## **MEETING AGENDA**

### **PLANNING COMMISSION**

**Monday, April 21, 2025, 5:00 P.M.**

## Sketch Plan Revision/Preliminary Plat

**STORM EXHIBIT**

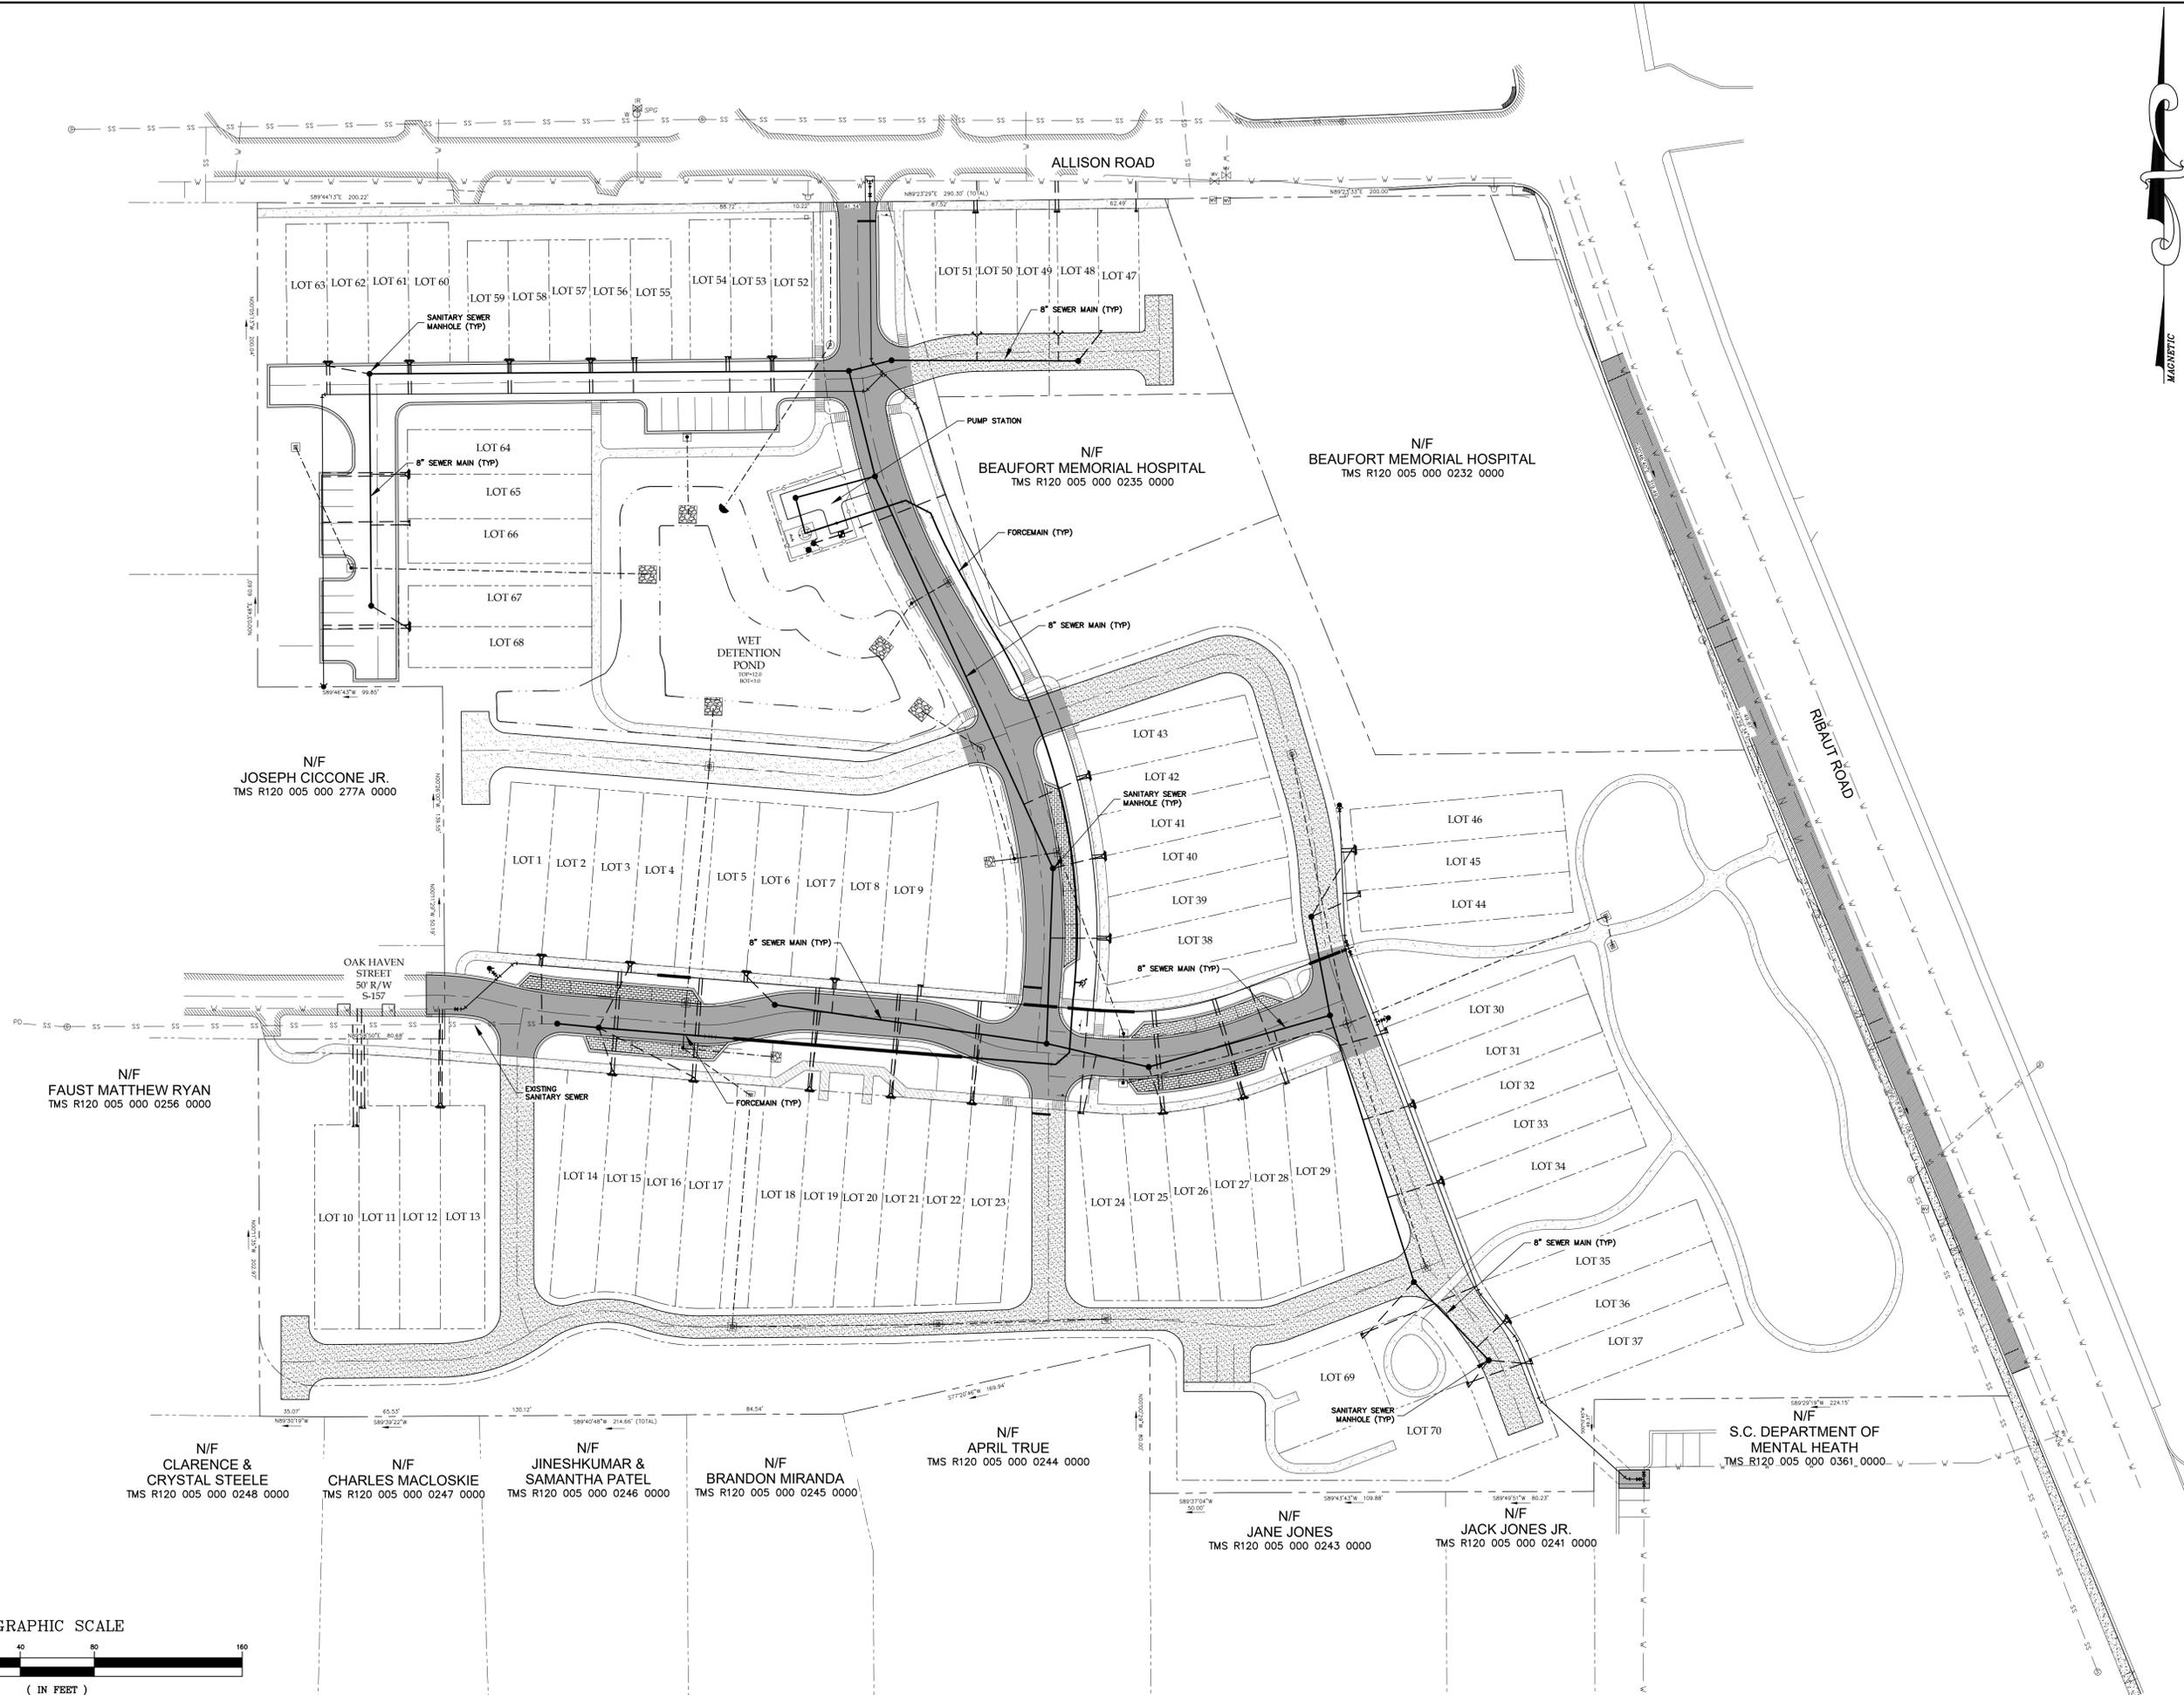
- 1) Will require PC meeting as per the Sketch Plan approval condition.
- 2) No vesting or platting occurred, and the project has changed so the project will need to meet SOLOCO standards.
- 3) No stormwater drainage plan was provided. This is generally part of any preliminary plat, as it will have a major impact on the design and layout of the subdivision.
- 4) Traffic impact & vehicular circulation / connectivity also has been well provided for, as numerous points of ingress/egress as well as new street connectivity is being established (SCDOT has approved the TIA as submitted). The accounted daily trips should even be less, as the commercial

The applicant has provided the attached grading and drainage plan illustrating the existing topography, proposed drainage patterns, stormwater collection, and drainage outfall

- 1) **Stormwater**: resolved, and the applicant is now proposing a compliant stormwater plan.
- 2) **Traffic impact & vehicular circulation**: Staff and the Applicant met to discuss concerns about the Ribaut Road access point, and thru traffic on Oakhaven. Staff's concerns included safety concerns about full access drive 320' away from Allison Road, site distance, and thru traffic. After

DRAWING TITLE  
**PLANTING PLAN**

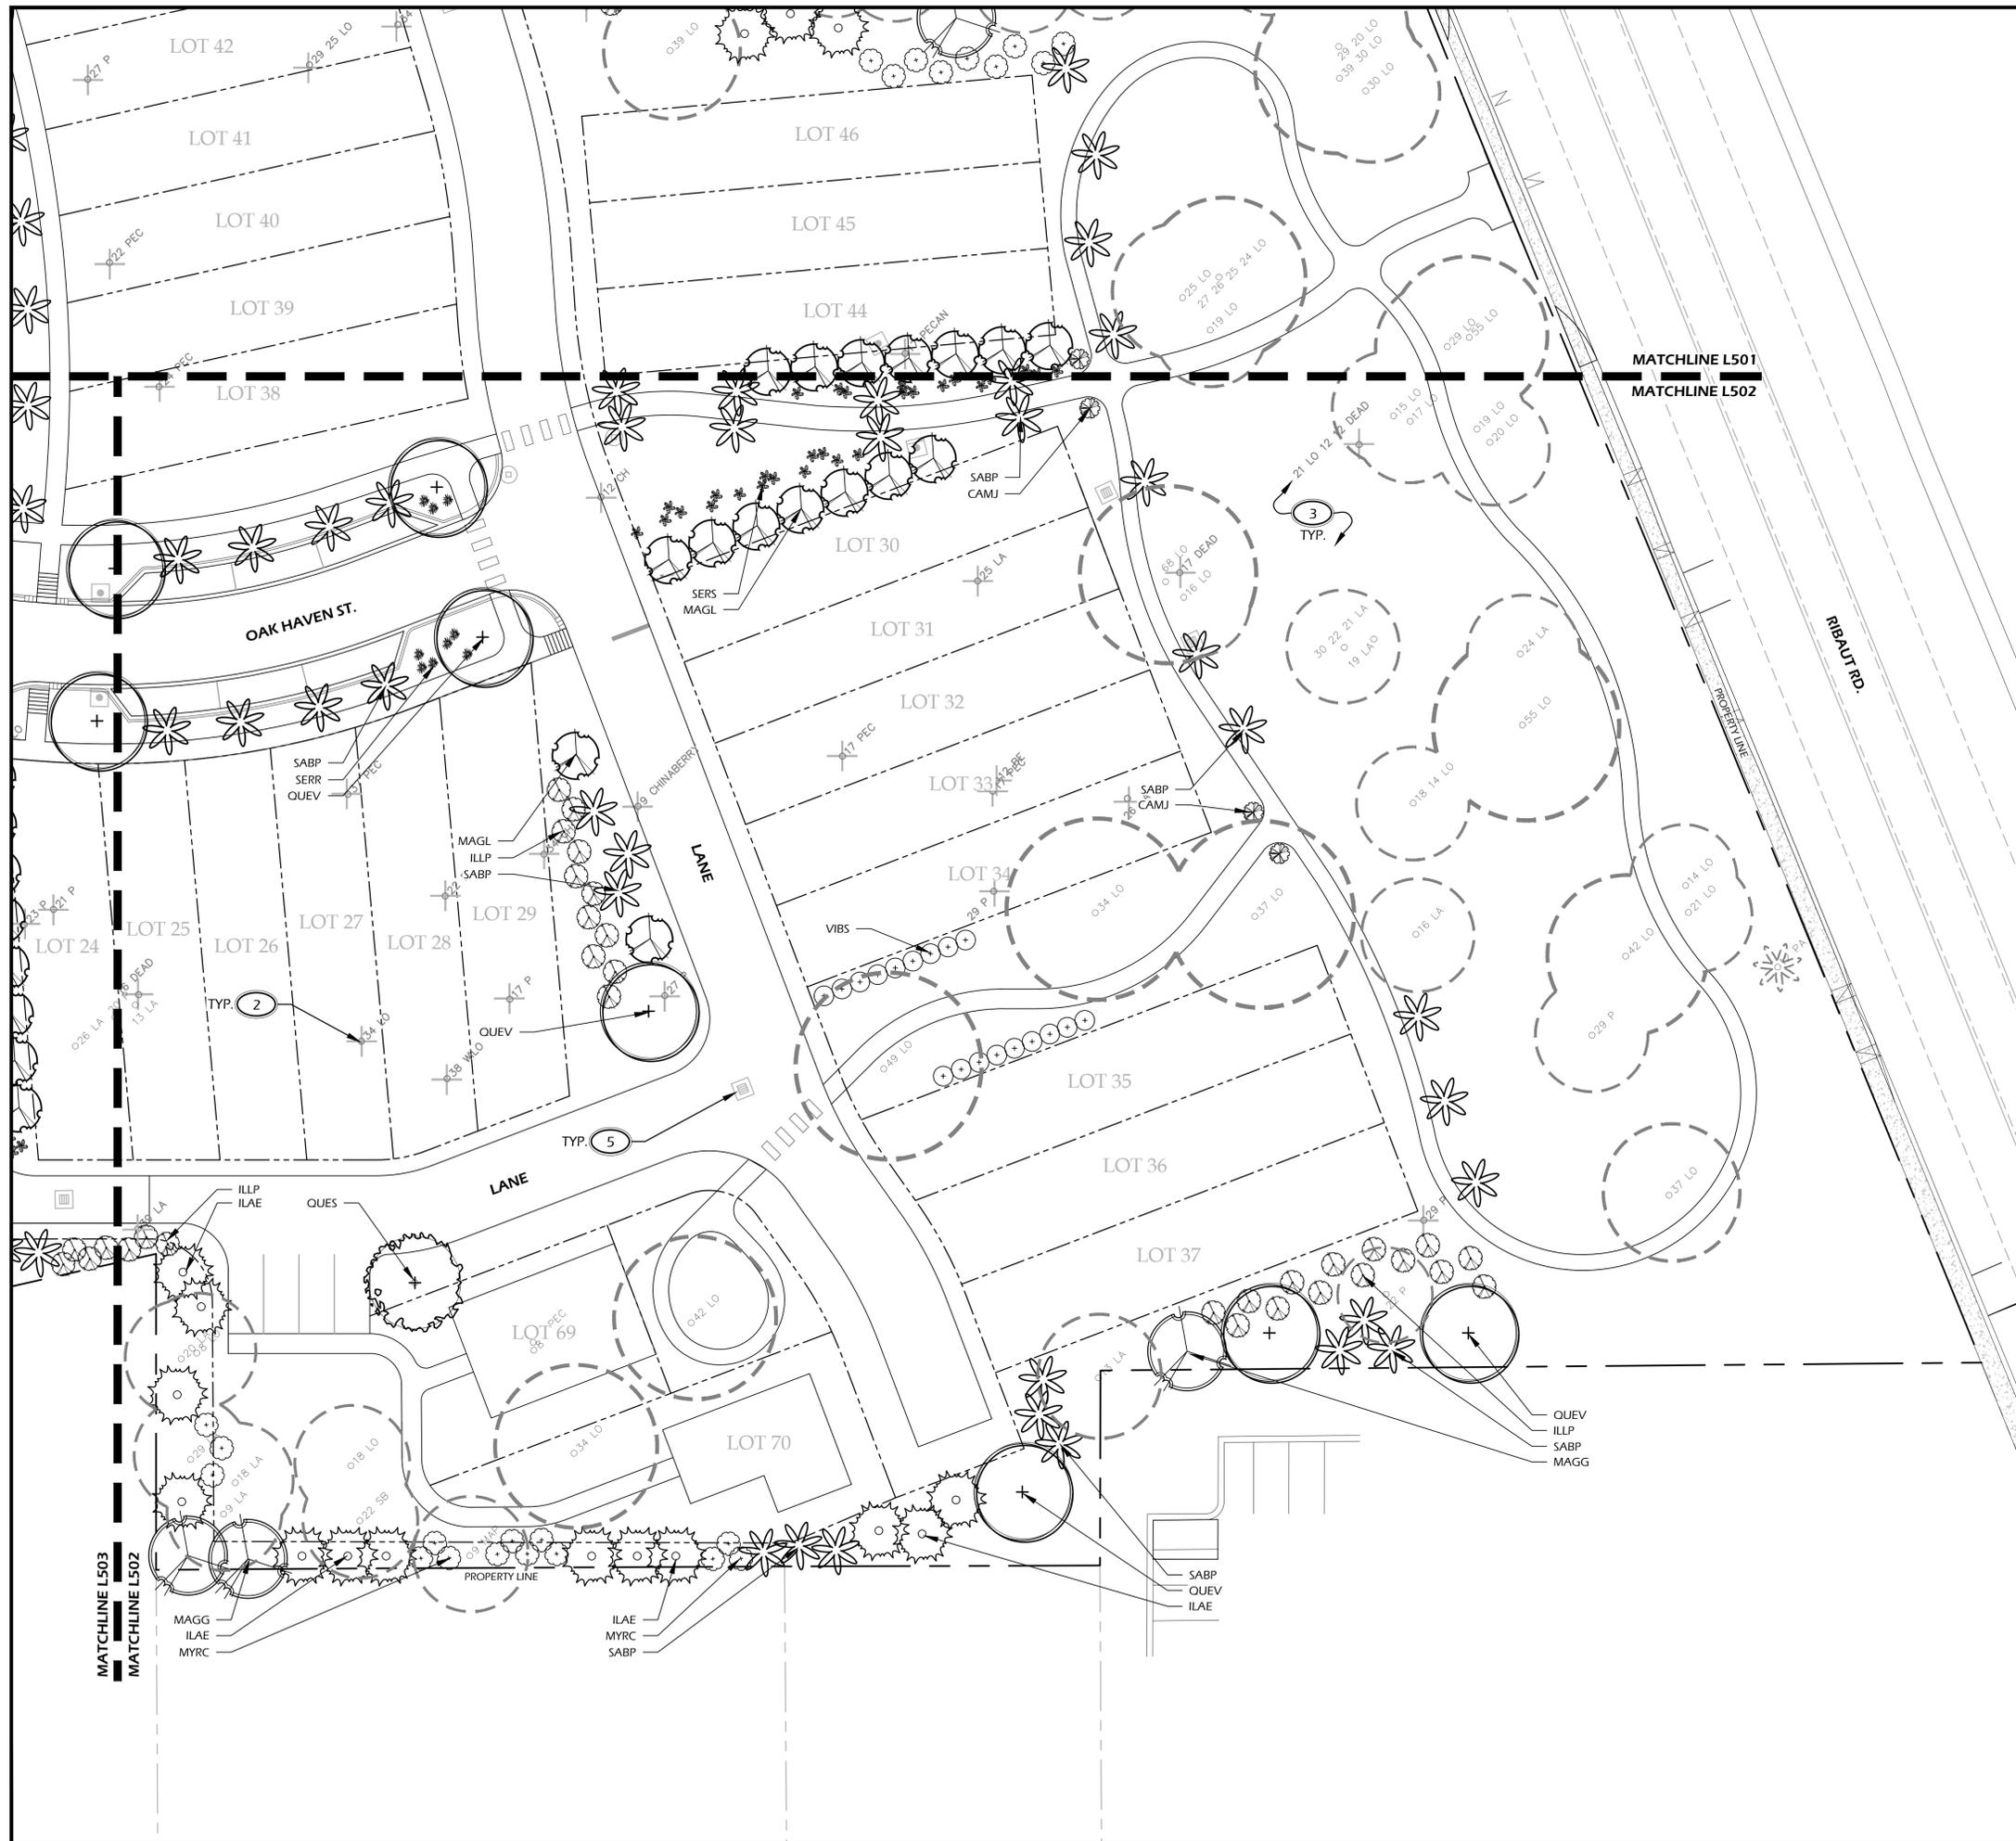
4. Plans if any for screening of property perimeters;

New landscape plans with screening are now provided. The submittal landscape plan includes the addition of overstory trees (live oak , magnolia), understory trees (holly , palmetto's) and large shrubs (wax myrtle, yellow anise, sabal minor and viburnum). The proposed planting is to provide infill and provide a buffer along the perimeter property lines.
